**RE: 551-557 FINCHLEY ROAD – ENERGY, SUSTAINABILITY AND AIR QUALITY**

This letter provides a response and further clarifications requested by Haringey in their emails dated on 16 April 2020 which commented on the submission for 551-557 Finchley Road.

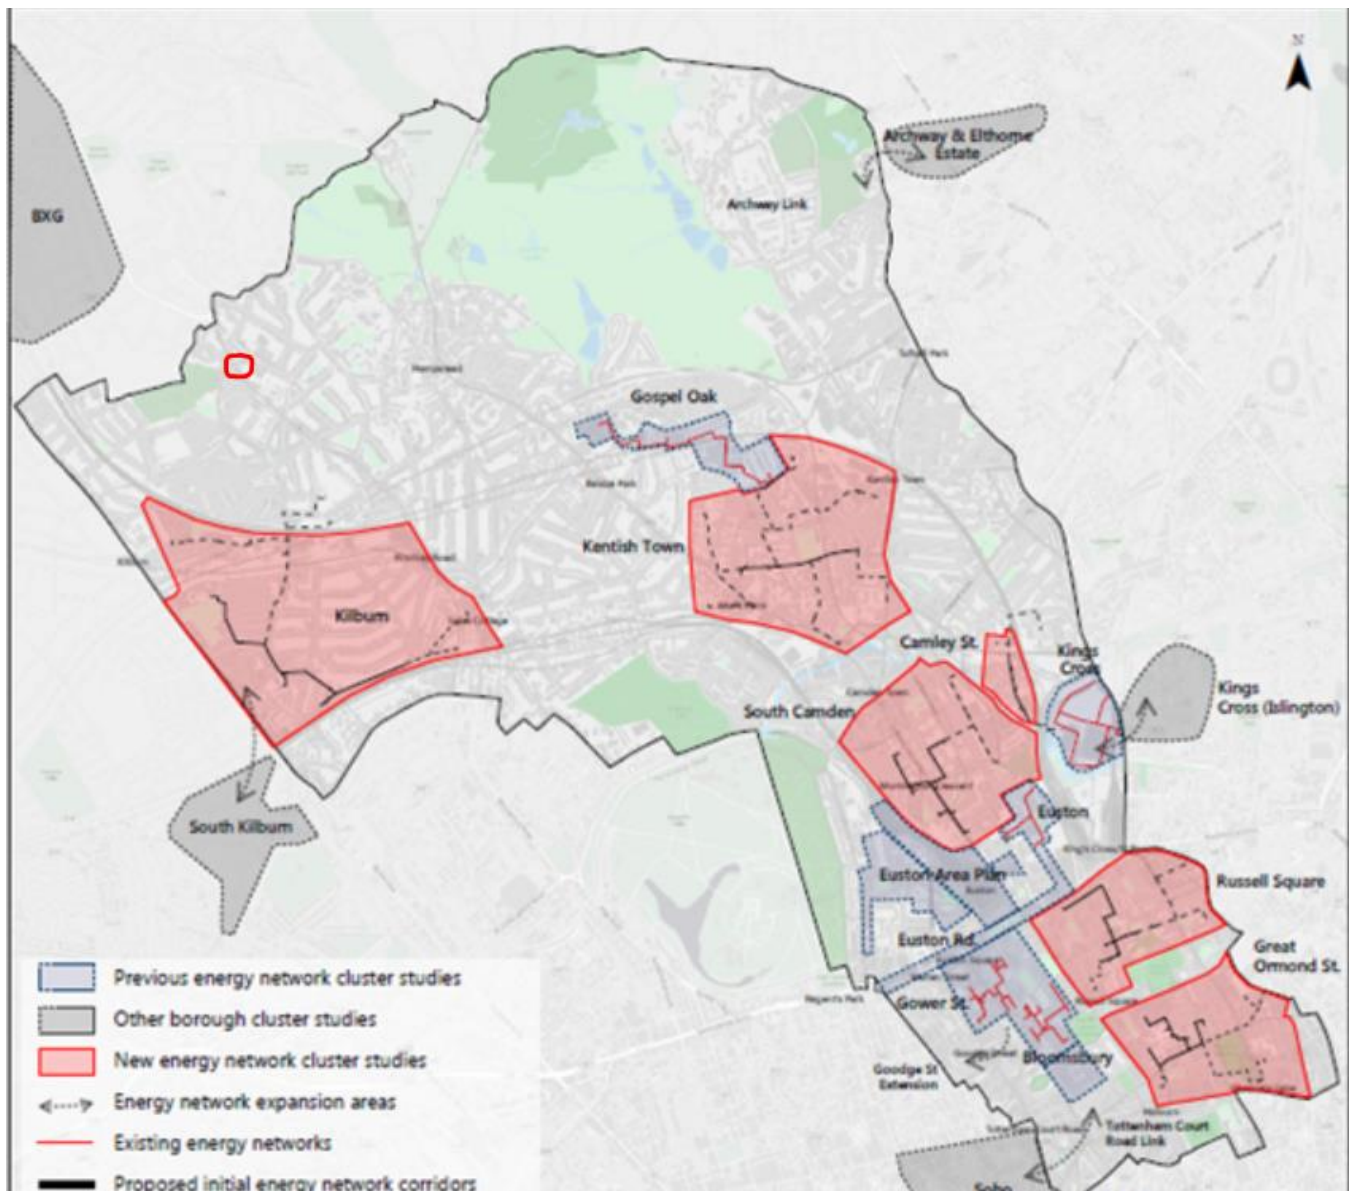
- GLA guidance on preparing energy assessments and CPG 'Energy Efficiency and Adaptation' (here) should be followed. The London Plan (Policy 5.5) requires developers to prioritise connection to existing or planned decentralised energy networks where feasible. Camden's Local Plan Policy CC1) requires all major developments to assess the feasibility of connecting to an existing decentralised energy network, or where this is not possible establishing a new network. NOTE: Decentralised Energy Priority Areas are shown on this map].

The feasibility of connecting to a network has been assessed in the submitted Energy Statement. The image below also shows in a red circle the site location on the map referred to in the comment above where it is shown that there is no opportunity for DEN connection. In any case, the proposed development plantroom could be amended in the future to install heat exchangers as opposed to a gas boiler so as to draw heat from a heat network, if one becomes available in the future.
